San Juan 27-4 Unit #60F, API# 30-039-30203

HILCORP ENERGY COMPANY
SAN JUAN 27-4 UNIT 60F
PICTURED CLIFFS RECOMPLETION SUNDRY

Revised Perfs

Attachment to notice of Intent to
Recomplete and Commingle
Well: San Juan 27-4 Unit , #60F
CONDITIONS OF APPROVAL

SAN JUAN 27-4 UNIT 60F - CURRENT WELLBORE SCHEMATIC

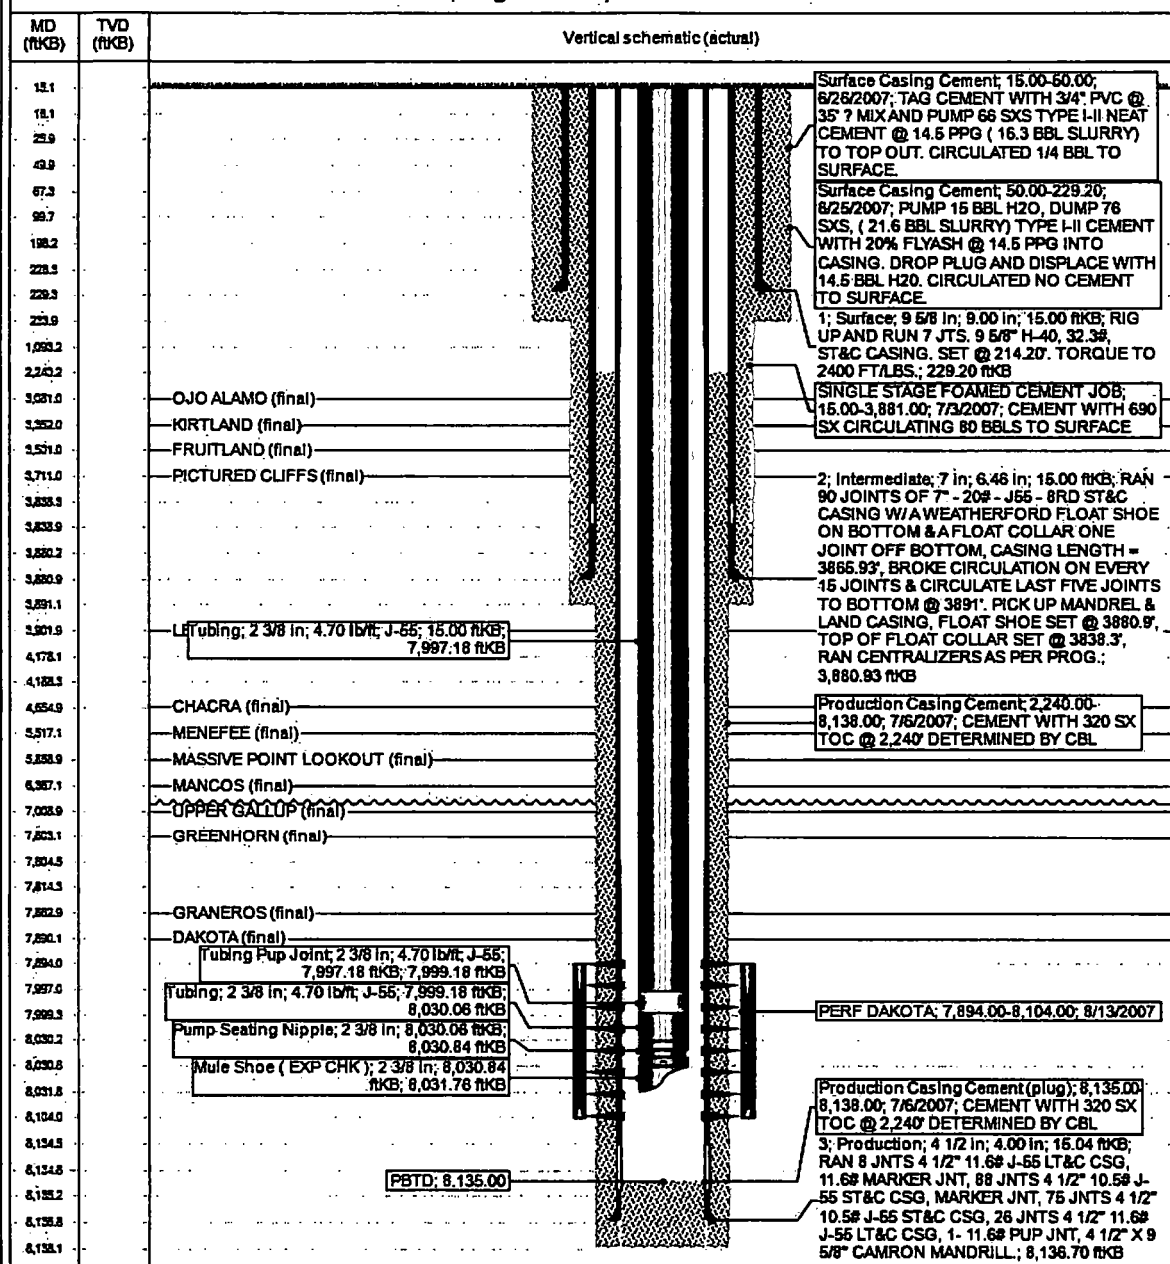
- See the revised sundry received by the OCD on 6/6/19 which included corrected PC perforations to ensure they were in formation.

2. The following modifications to your recompletion program are to be made:
 - a) Upon rigging up, record Bradenhead pressure and monitor same during recompletion operations. Notify BLM and NMOCD if anomalous pressure changes occur. Provide monitoring results on the Subsequent Report of Operations.
 - b) Casing pressure test for fracture stimulation operations cannot exceed the internal yield strength of the casing including a 20% safety factor unless a waiver is granted. Stimulation operations cannot exceed this test pressure.
3. File Well test and Recompletion results within 30 days of completing recompletion operations.
